18DEVPLAN1046

2326 Ralph Ave.

**Louisville Metro Board of Zoning Adjustment
Public Hearing**

Ross Allen, Planner I

SITE PLAN:
SCALE: 1" = 20'

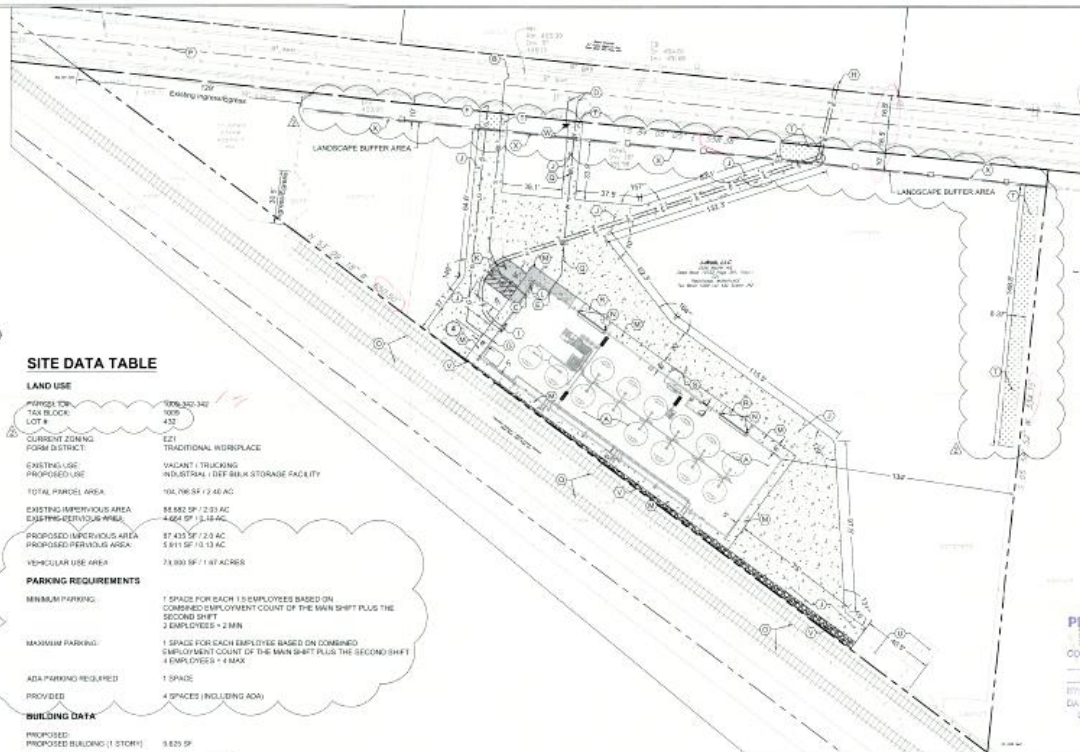
- Variance from (Shively, KY) LDC 5.2.5.C.4.a to allow the proposed 1-story (27 ft. $\frac{3}{4}$ in.) to exceed the 25 ft. maximum front setback at its farthest point by approximately 155 ft. south of the property line along Ralph Ave.

- Waiver #1 from (Shively, KY) LDC 5.8.1.B/5.9.2.A.1.b.i to not provide a sidewalk along the Ralph Ave. frontage for an approximate distance of 566 ft. and to not provide a clearly defined safe pedestrian access from the Ralph Ave. right of way to the non-residential building entrances.
- Waiver #2 from (Shively, KY) LDC 5.5.1.3.a to allow the parking/maneuvering area to be within the front setback and located closer to the right of way than the principal structure.

- Variance request appears to be adequately justified and meets the standard of review.
- Waivers # 1 and 2 appear to be adequately justified and meets the Guidelines of the Comprehensive Plan (Cornerstone 2020).
